### Record, Decision and Site Plan Approval

ZBA 2015-35  
Petition of Robert & Elin Paltrineri  
22 Pleasant Street

**DRAWING TITLE:** GRADING & DRAINAGE  
LOTS 96, 97, & 98

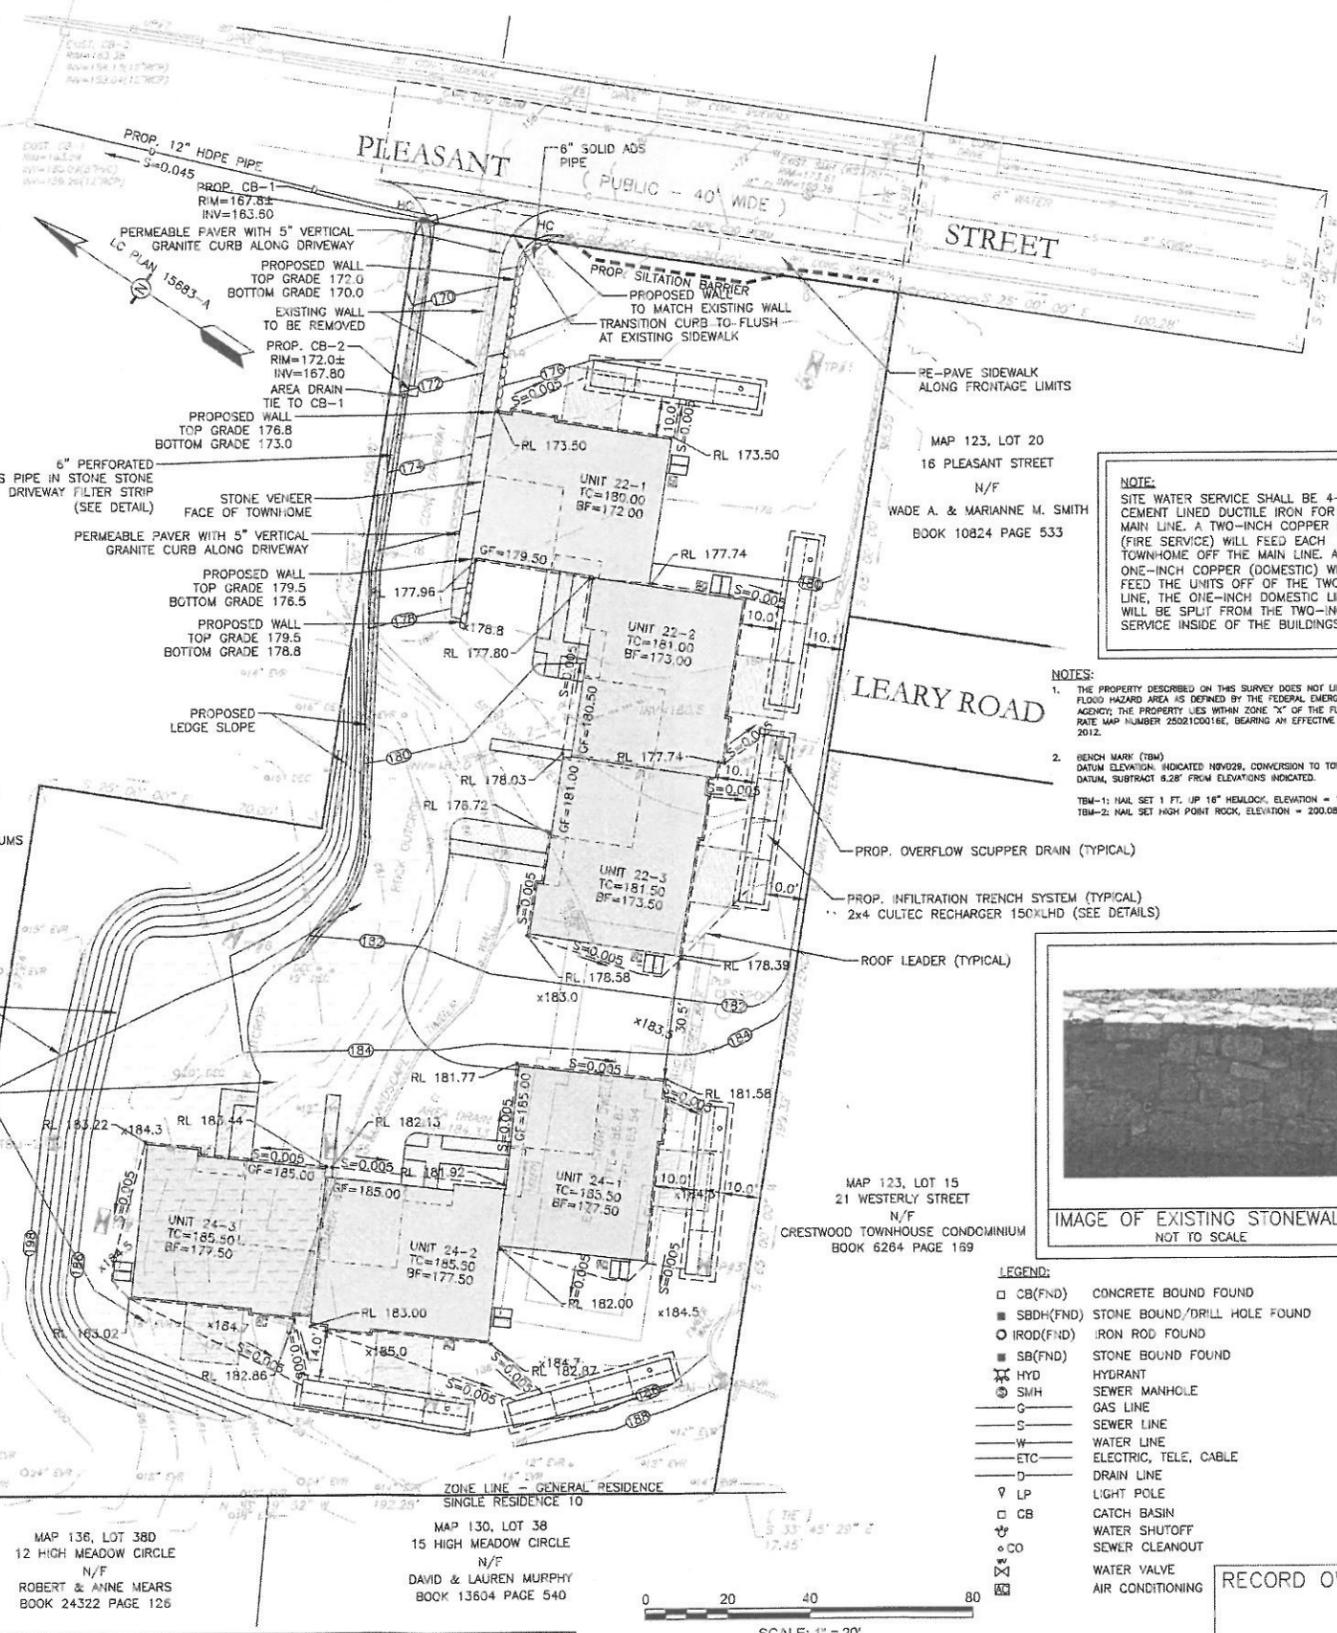
The Board said that there is no drain at the bottom of the driveway. Mr. Bemis said that there is a double catch basin shown on Sheet 2.

The Board asked about blasting to impermeable surface and drainage. Mr. Bemis said that blasting is identified on the plan. He said that there is a note on Sheet 2 stating that any area blasted will be reduced 2 feet to assure that they have a permeable gravel material at the blasting area to pick up stormwater and lead it away properly.

The Board asked about the blasting and grass paved area. The Board said that the rock surface will be taken two feet below the bottom of the finish. The Board asked if there is a way for water that sits on the rock to slide off and go elsewhere. Mr. Bemis said that they could accept a condition or add a detail about channeling the water.

15. Blasting within the limits shown on Sheet 2 is specifically permitted, provided that the Applicant is required to comply with 527CMR1.00 requirements for blasting. Further, neither blasting nor noisy operations such as rock drilling or rock excavation shall be permitted to commence prior to 8:00 a.m. Monday through Friday, and such operations shall be completed by 4:00 p.m. Monday through Friday. For those days in which the Sprague School is in session, blasting shall be prohibited during the hours of 8:00-9:00 a.m. Monday through Friday or 2:30-3:30 p.m. Monday, Tuesday, Thursday and Friday. On each occasion, at least two hours advance notice of blasting shall be given to all abutters and such other neighbors as the regulations may require.

- APPROXIMATE LEDGE REMOVAL AREA SHALL BE EXCAVATED TO A MINIMUM OF 2- FEET BELOW PROPOSED GRADES. (SEE HATCHED AREA FOR BLASTING LIMITS)
  - ALL ROOF LEADERS TO BE 6" DIAMETER ADS SOLID PIPE CONNECTED TO INFILTRATION SYSTEMS WITH MINIMUM SLOPE OF 0.5%.

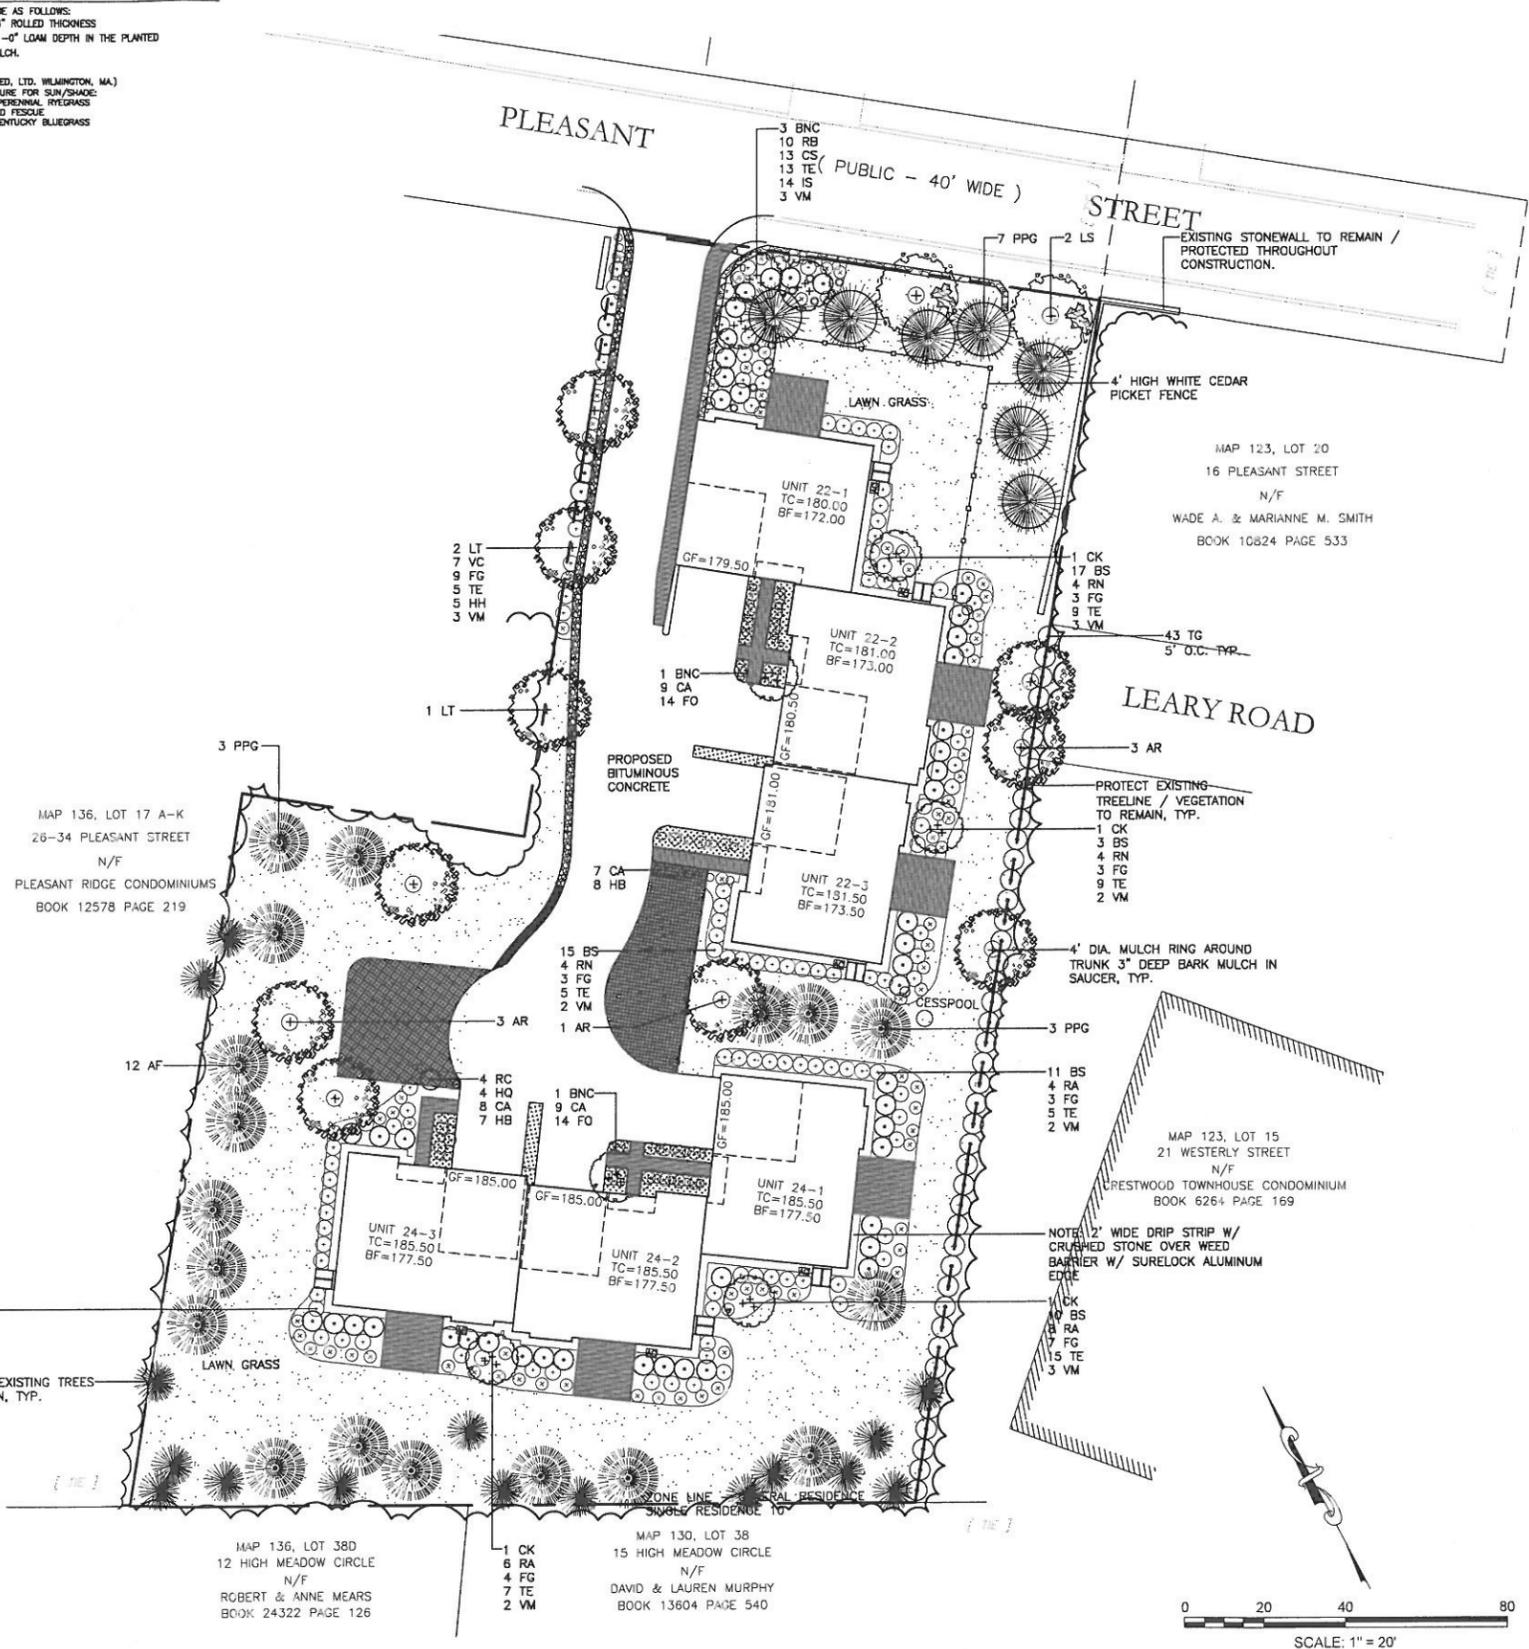
The Board asked if there is a reason why the grass pavers are not shown on the landscape plan. The Board said that there looks to be some conflicts with trees in the grass paver areas. Mr. Bemis said that those areas a just lawn that someone can drive over.

Mr. Bemis said that on the Landscape Plan they moved some things wherever there was a conflict with the other modifications. He said that it will be the same amount of plant material.

10. Along the northern-most and southern-most boundaries of the Site, the Applicant shall provide the trees and plantings as shown on the Sheet 5 to provide screening of the Project from the adjacent properties on Pleasant Street. The final landscaping plans shall use no trees smaller in caliper and shorter in height than those shown on the Sheet 5 without the consent of the Board.

19. Landscaping shall be in conformance with the Landscaping Plan and shall be maintained, repaired, or replaced as needed by the Applicant or by the Condominium Association. For the plantings along the southern-most boundary, especially those that comprise the screening with the adjacent properties on Pleasant Street, in the event that construction activities cause any of the existing trees or plantings to die within two years of the completion of construction, the Applicant will replace the failed tree(s) with the tree in the Plant Schedule shown on Sheet 5 that is closest in species and closest in size to the tree or planting that died. In the event that any new plantings die within two years of the completion of the construction, the Applicant will replace the failed plantings with like species and size as that shown in the Plant Schedule.
